HARDEE UNIT 3

Site Certification
Application/Environmental
Analysis

Sufficiency Comments/
Applicant Responses

August 1994

FDEP.BWRM-10

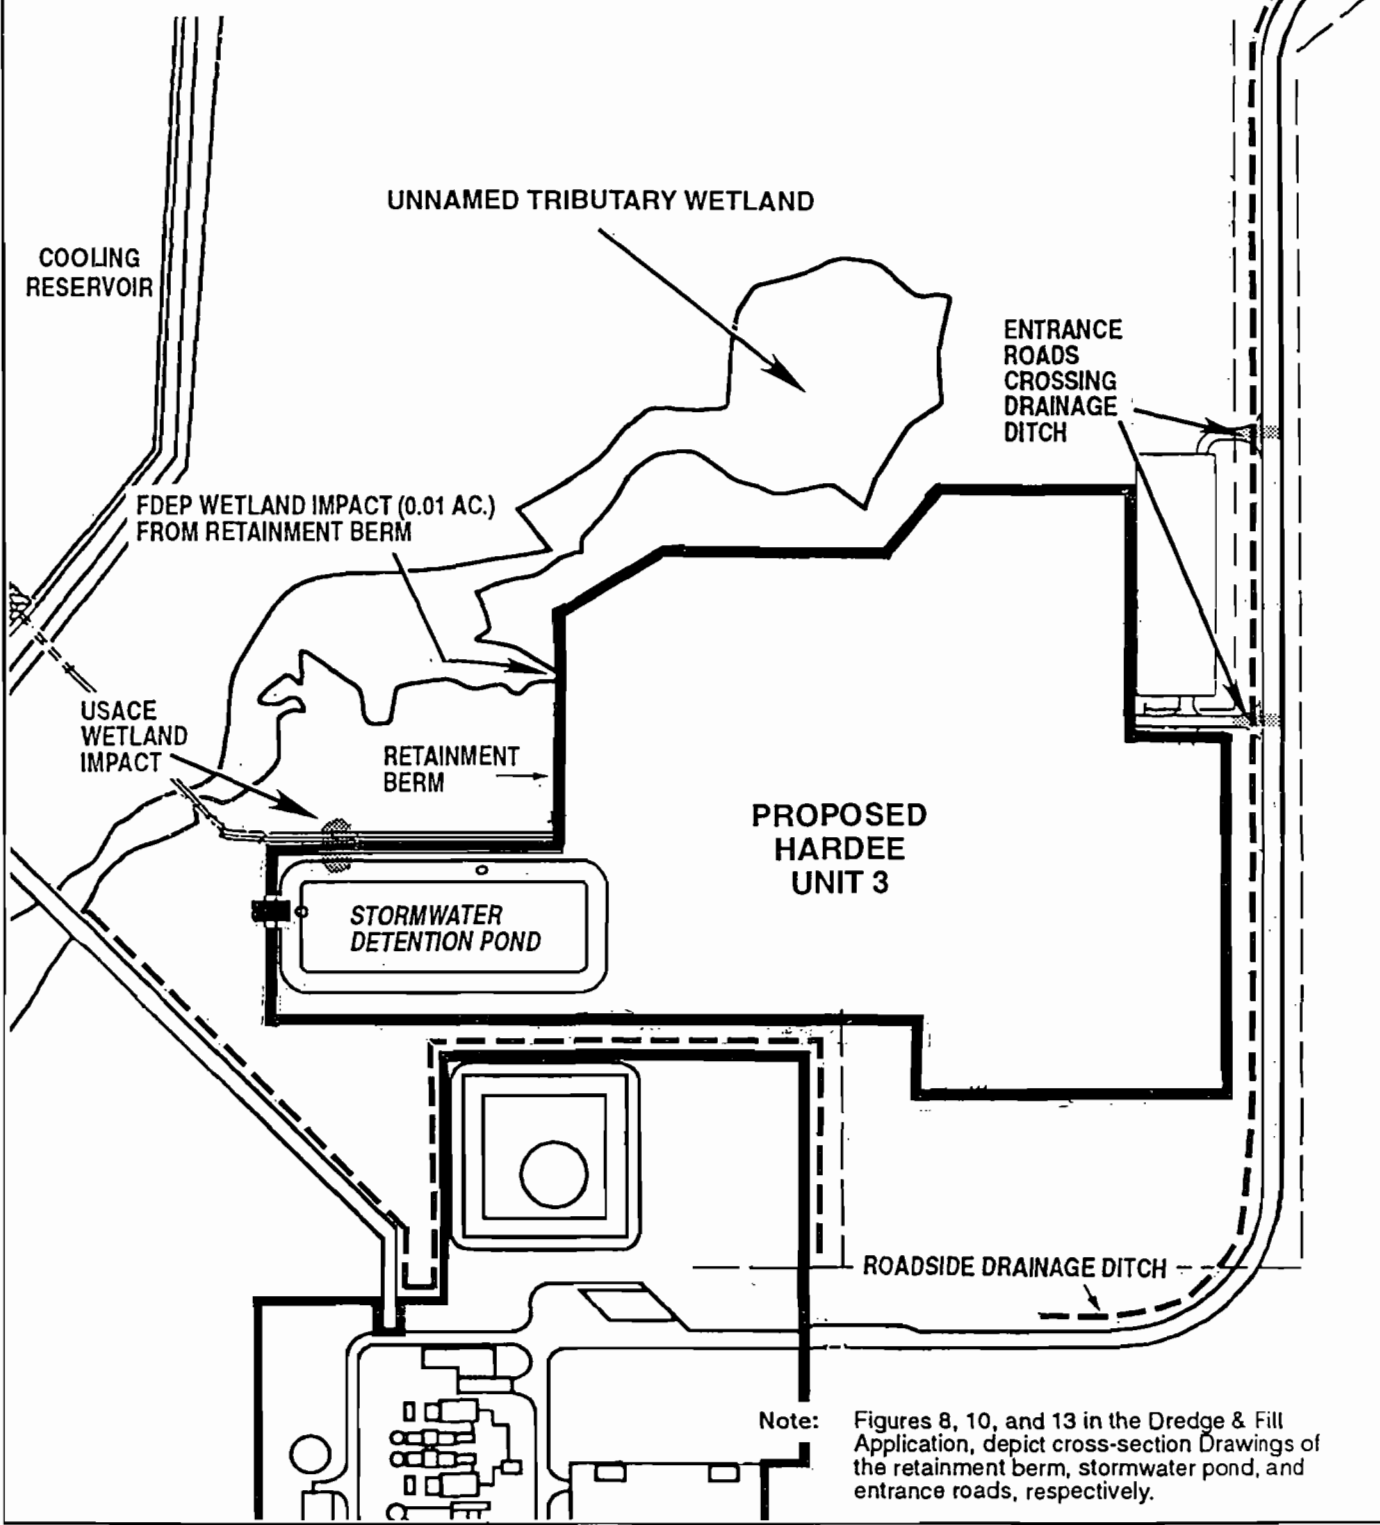
Comment: Please provide a vegetation species list for the plants currently found at the mitigation site and at what elevation each species is found.

Response: Tables FDEP.BWRM-10.1 and FDEP.BWRM-10.2 list the vegetation present by elevation for both the wetland creation site and the wetland restoration site, respectively.

Figure 5
 Cross Section of the Wetland Creation Site
 (Revised 08/23/94)

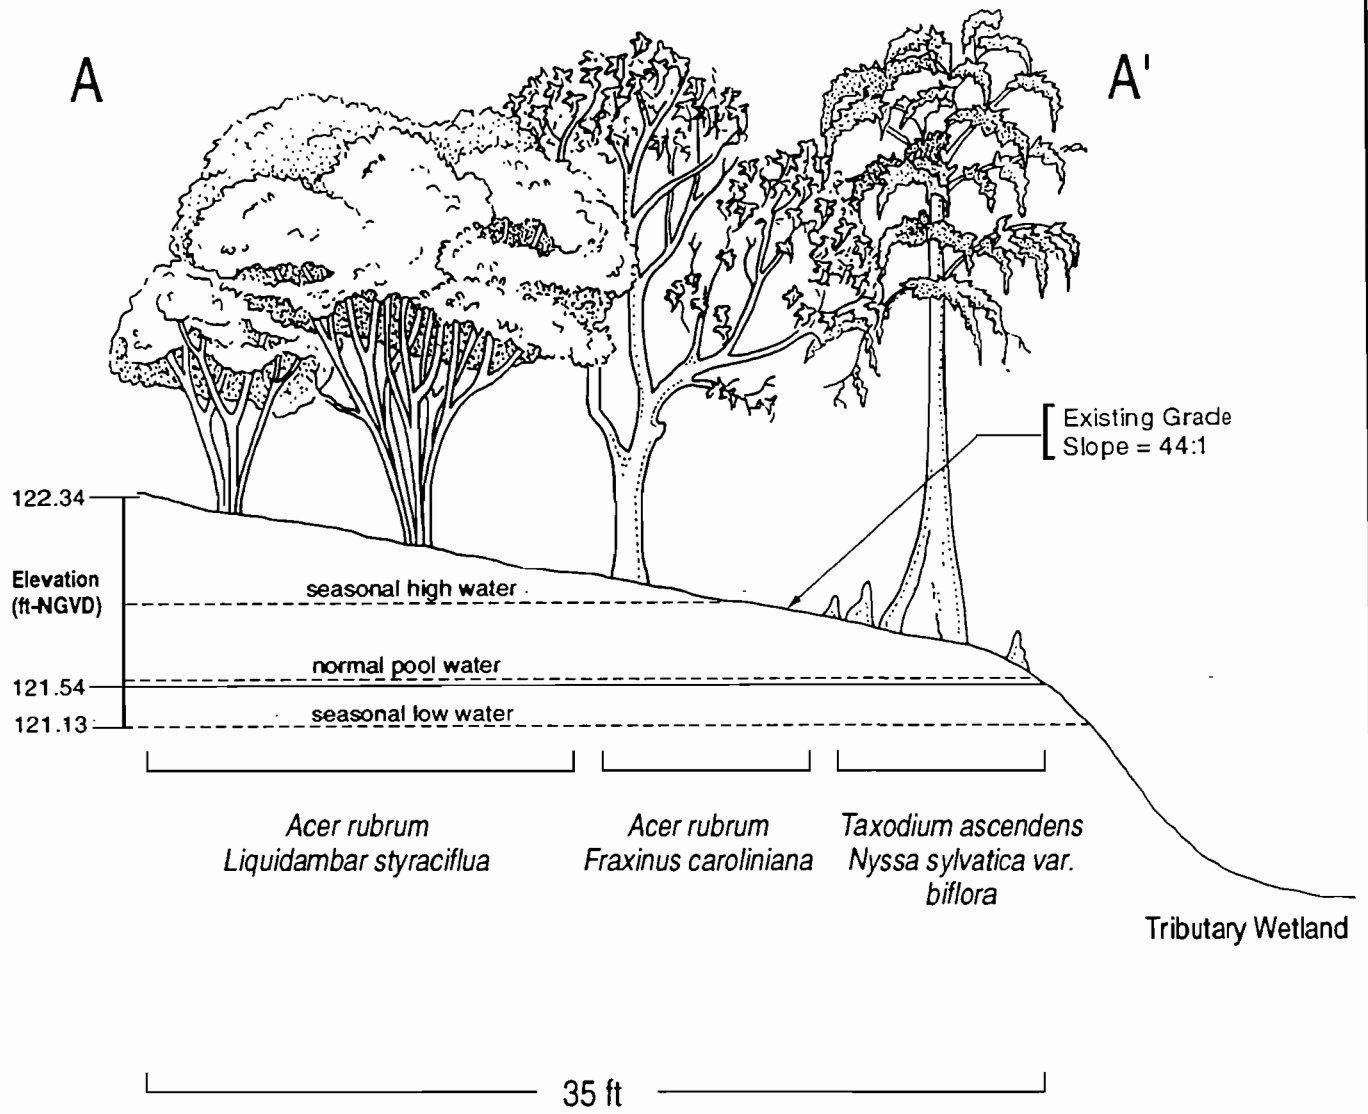
11. Please revise the mitigation cross-sections to show the vertical elevation related to NGVD and seasonal high and low water.

Response: The revised mitigation cross-section drawings are attached as Figures 5 and 6.

Figure 5
 Plan View of the Circulating Water Pipes Crossing the Wetland
 (Revised 8/22/94)

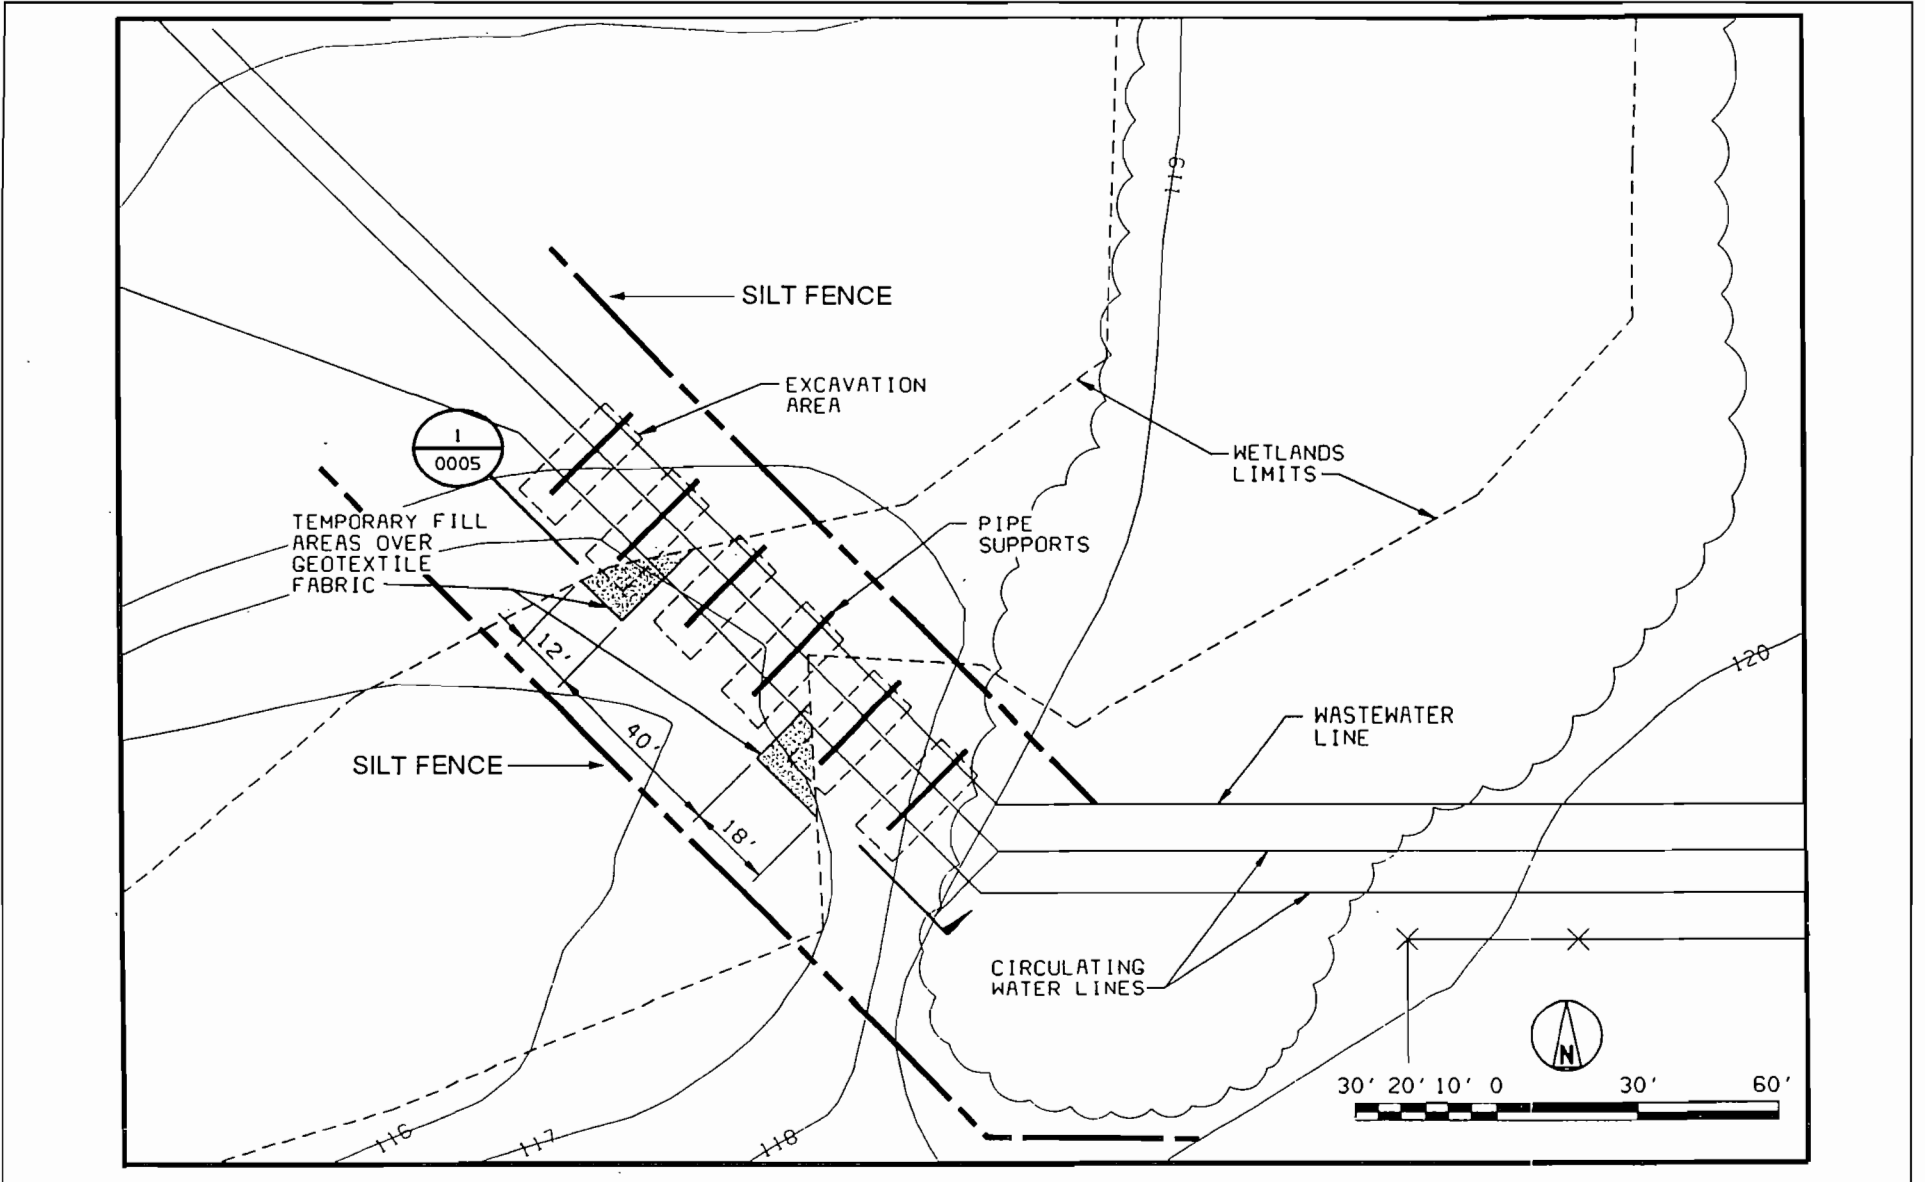
7. Please clarify the purpose of the ditch at the base of the retainment berm.
8. The drawings for the wetland impacts are illegible, with the exception of the pipeline. Please provide plan view and cross-section drawings similar to the pipeline drawings for the other wetland impacts.

Response: Temporary measures will be used during construction to control erosion and sediment transfer from the site. Silt fences will be used to filter sediments washed from grading areas where the ground slopes away from the site. Areas disturbed during grading operations will be seeded to establish a vegetative cover to reduce erosion on the site. A more detailed description of sedimentation measures is provided in the Erosion and Sedimentation Control Plan in Appendix 10.9 of the SCA. The location of all silt fences is shown on the attached revised Figures 5, 7, 9, and 12 from the dredge and fill permit application.

SWFWMD-C1
 Location of Existing Production Wells on the HPS Site

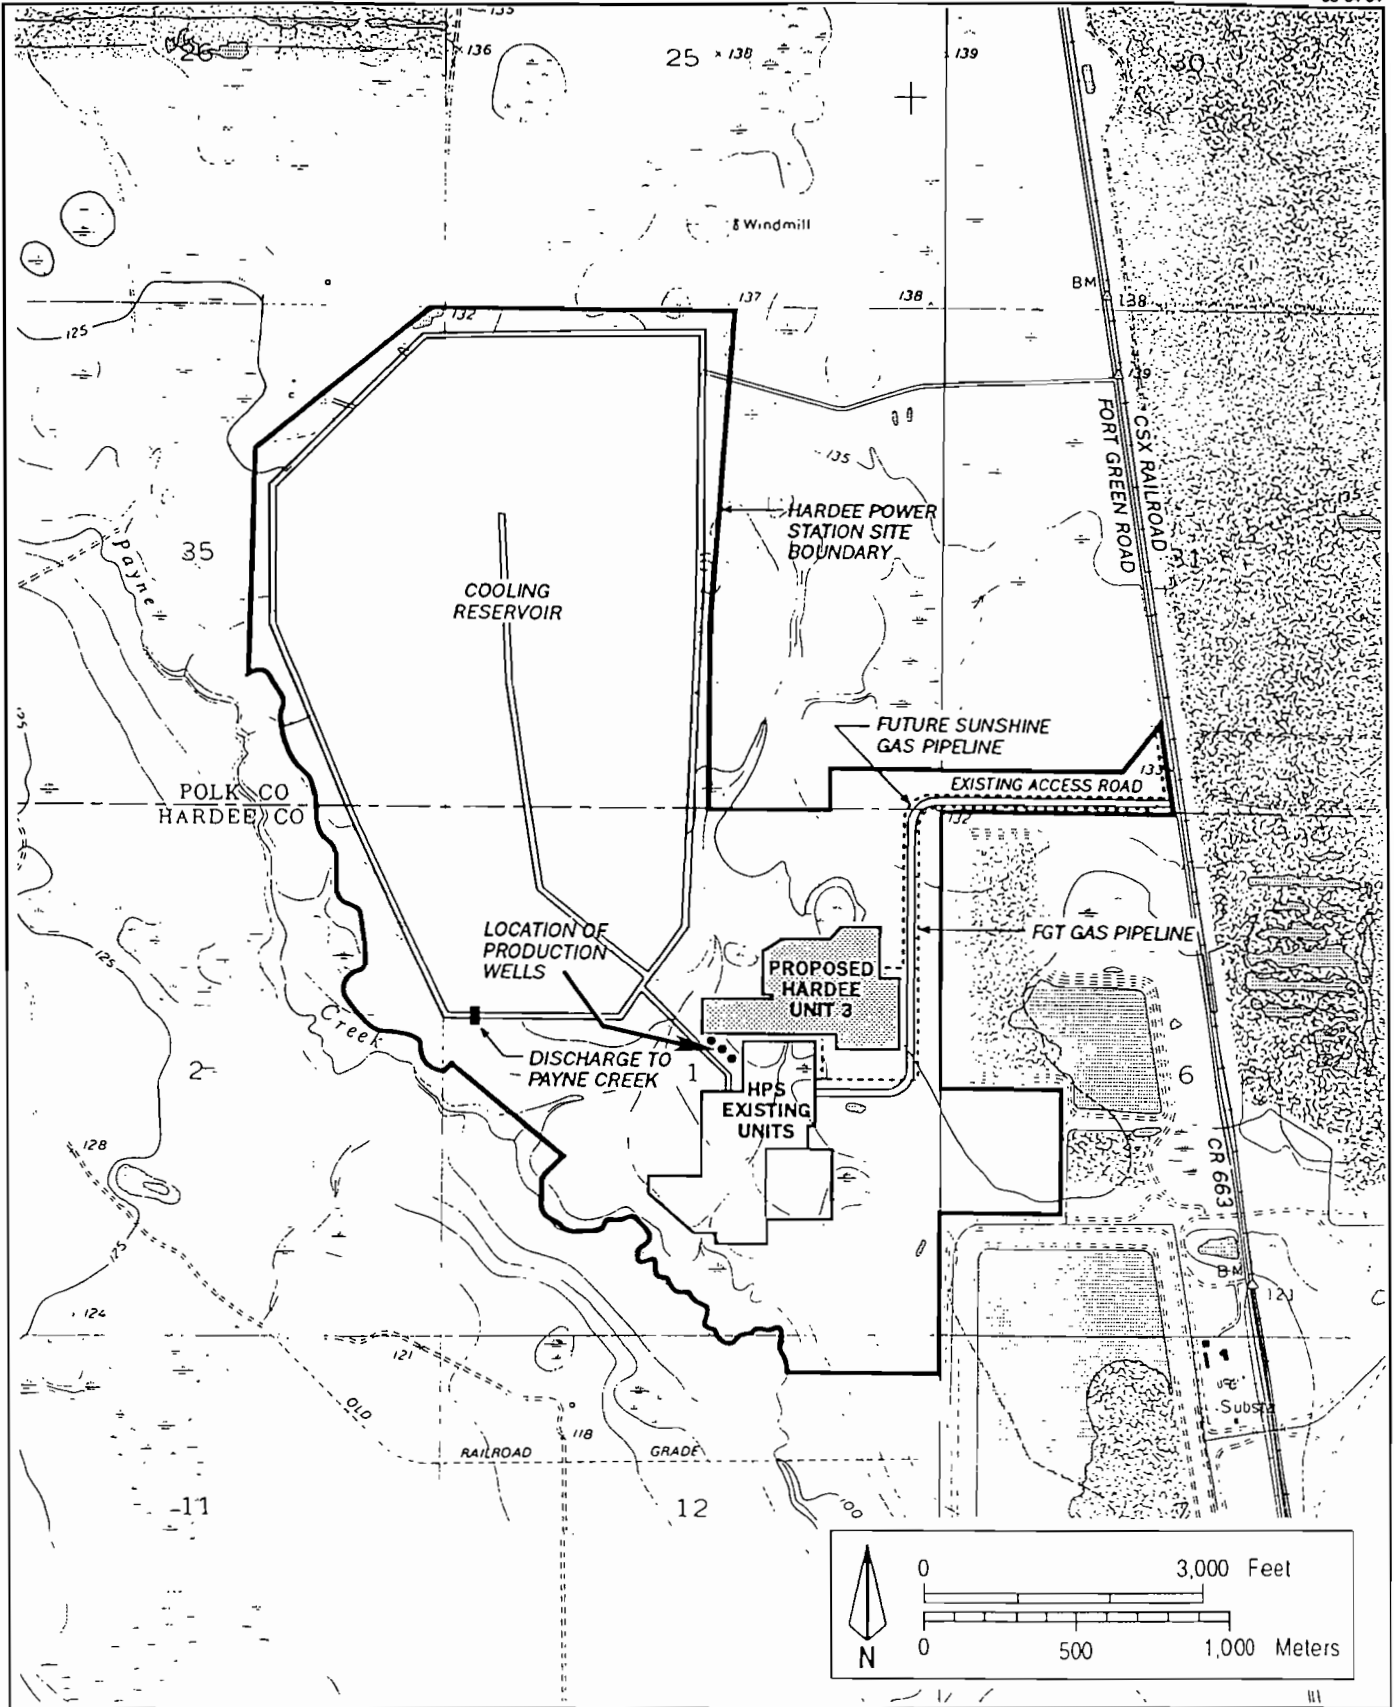
Comment: Please provide a map, not necessarily an aerial, indicating the specific location of the three existing wells, District ID Nos. 1, 2, & 3. Indicate the distances in feet to the nearest north/south and east/west property boundaries. Also, please indicate any numbering/identification system you have placed on these points for referencing.

Response: A map of the Hardee Power Station showing the approximate location of the proposed Hardee Unit 3 facility and the location of the three existing production wells is provide as Figure SWFWMD-C1. These wells are a minimum of 2,200 feet from the nearest east/west property boundary, and a minimum of 3,000 feet from the nearest north/south property boundary. The existing groundwater wells at Hardee Power Station have the following district ID numbers: 209731.00 for Well ID 1, Well ID 2, and Well ID 3.

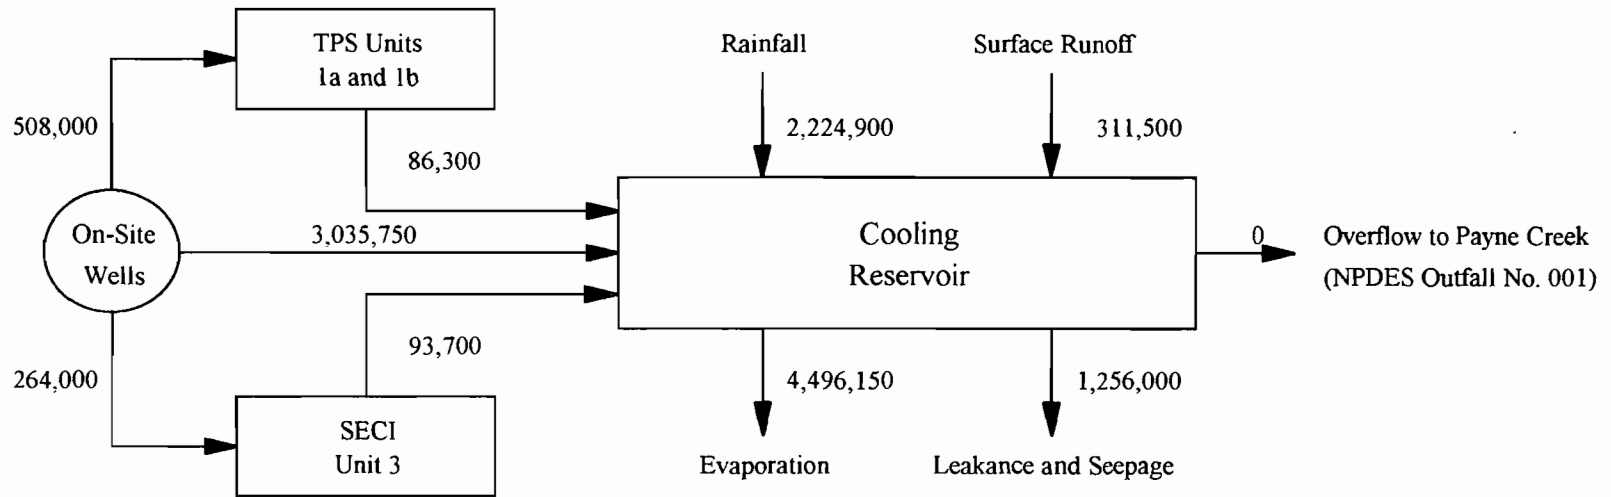
Comment: The Water Balance Diagram submitted in support of your SCA, Figure 3.5.0.1, Cooling Reservoir Water Balance, Annual Average Conditions for 880-MW Buildout, indicates an Annual Average Daily quantity of 3.174 MGD from the deep wells, however, your application indicates the current allocation under the Site Certification is 3.8 MGD. Please provide revised water balance diagrams (i.e., diagrams for the proposed 440-MW Hardee Unit 3 and the build-out of 880-MW) consistent with the quantities currently allocated for the Site Certification.

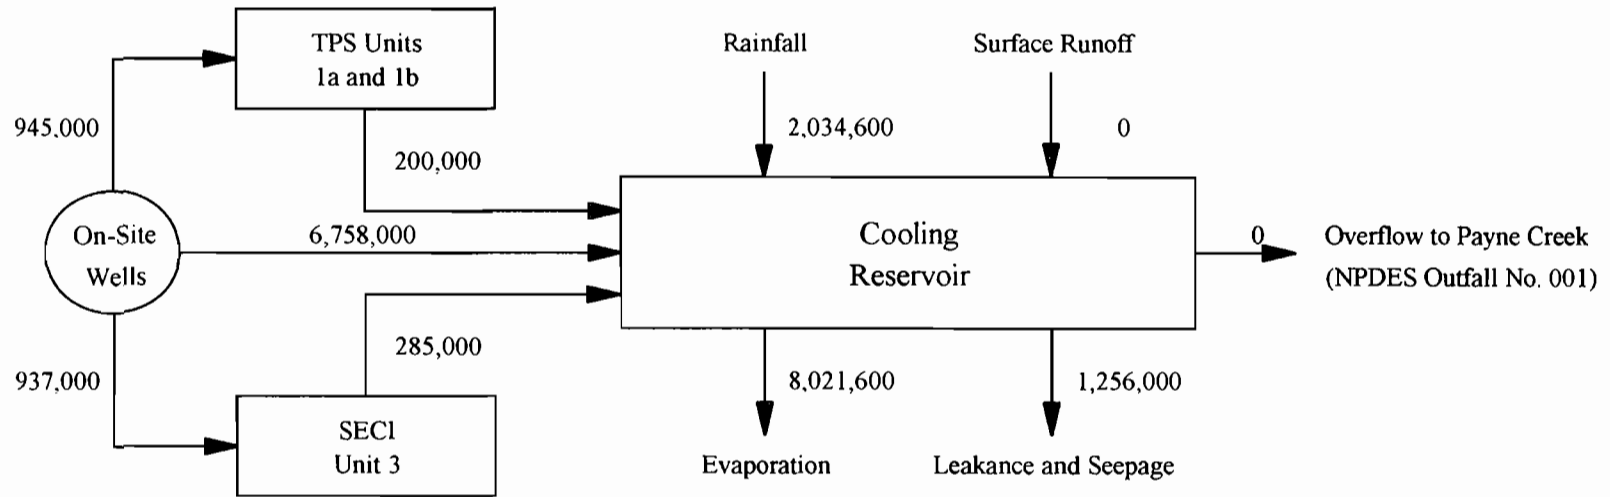
Comment: The Water Balance Diagram submitted in support of your SCA, Figure 3.5.0.2, Cooling Reservoir Water Balance - Worst Case Monthly Conditions for 880-MW Building, indicates a Peak Month Daily quantity of 7.17 MGD from the deep wells, however, your application indicates the current allocation under the Site Certification is 8.64 MGD. Please provide revised water balance diagrams (i.e., diagrams from the proposed 440-MW Hardee Unit 3 and the build-out of 880-MW) consistent with the quantities currently allocated for the Site Certification.

Response: A revised water budget for the daily maximum case based on the Log-Pearson Type III analysis is shown in Figure SWFWMD-C3. The 8.64-mgd daily maximum value is derived from a statistical analysis of the reservoir model. In the reservoir model, groundwater withdrawals are a summation of the reservoir makeup requirements; Units 1a, 1b, and 2 plant service water requirements; and Unit 3 plant service water requirements (for the 880-MW ultimate site capacity). The values shown in this revised water balance are the component values associated with an 8.64-mgd maximum daily withdrawal.
